THE MARYLAND-NATIONAL CAPITAL PARK AND PLANNING COMMISSION

MEMORANDUM

REVIEW TYPE: Preliminary Plan and Site Plan Review
APPLYING FOR: R-200/MPDU Option; 11.2 Acres;
25 Lots - 19 Single Family Detached Dwelling Units, 6 Single Family
Semi-Detached Dwelling Units

PROJECT NAME: **Bonifant Park**
CASE #: Preliminary Plan No. 1-02037 – Site Plan No. 8-02011
REVIEW BASIS: Request is Being Considered Under the Special Ceiling Allocation for
Affordable Housing Pursuant to the FY 2002 Annual Growth Policy
Requiring Site Plan Review - Article 59-D
Waiver Requested to Eliminate Sidewalks On One Side of the Proposed
Public Street, Subd. Regs. 50-26(h)

PRELIMINARY SUBDIVISION PLAN
LOTS 1-25, Parcels A - E
BONIFANT PARK
P. 3531, P. 3565, P. 364 & P. 485
13TH ELECTRON DISTRICT - MONTGOMERY COUNTY - MARYLAND

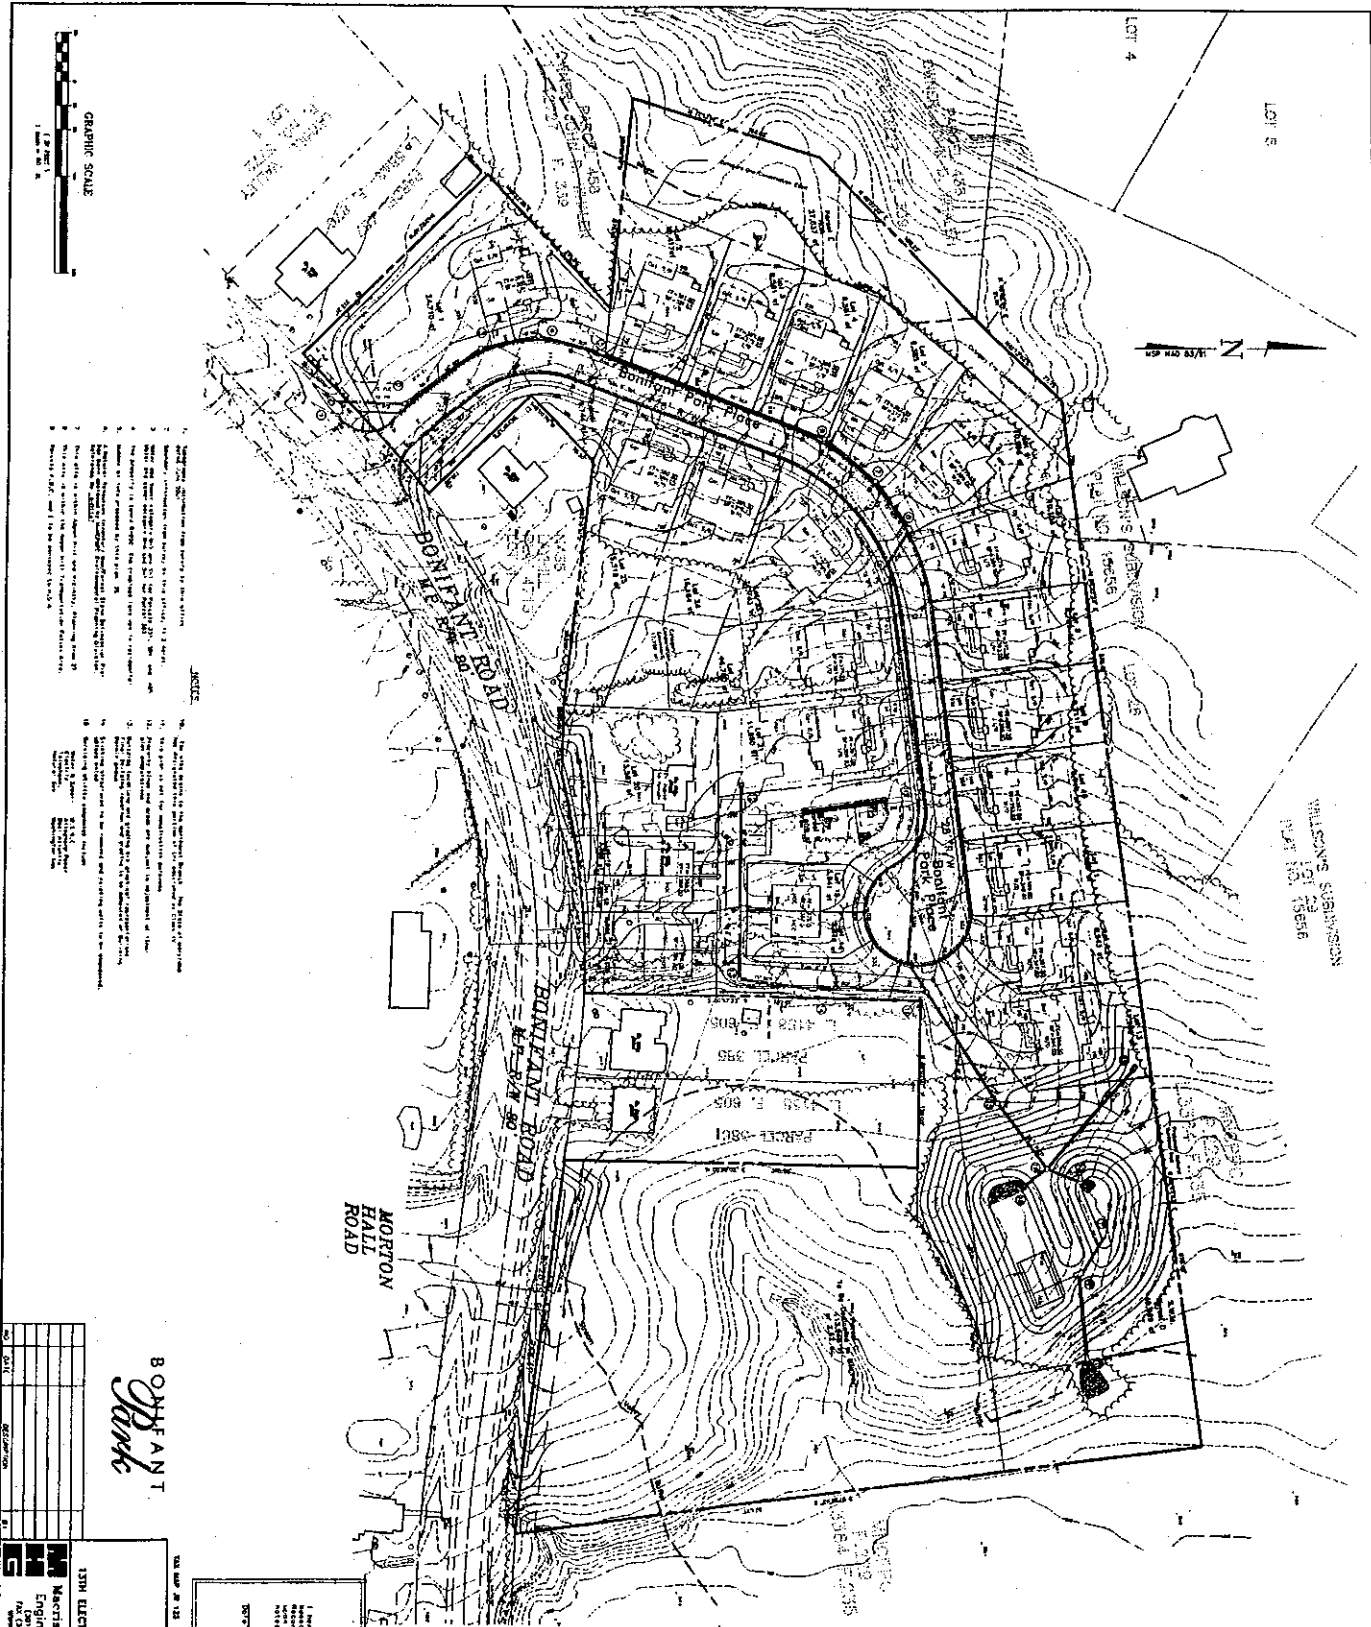
- b. Final Landscape and Lighting Plan to show the following:
 - i. Provide additional evergreen landscaping to the rear of lots 6, 7, 8, 9, 10, 11, and 12 to provide additional screening for existing Lots 27 and 28 adjacent to the site

- ii. Provide 5 ft. concrete walk on south side of proposed street
 - iii. Recreational amenities and the proposed asphalt trail through Parcel D to be constructed by the applicant at 70% completion or prior to release of the building permit for the 19th lot

A waiver is required for the site plan to eliminate the sidewalks on one side of the proposed public road. In order to approve the waiver, the Planning Board must find that pedestrian safety can be accommodated with the sidewalk located on one side only of the roadway. Previously, a waiver was approved for an overlength cul-de-sac with the Preliminary Plan #1-01037 [See Condition #11, Preliminary Plan].

Based on the number of units associated with this plan, staff finds that the pedestrian safety can be accommodated with the single sidewalk on the south side of the proposed road. M-NCPPC staff and DPW&T support the waiver request to eliminate the sidewalk
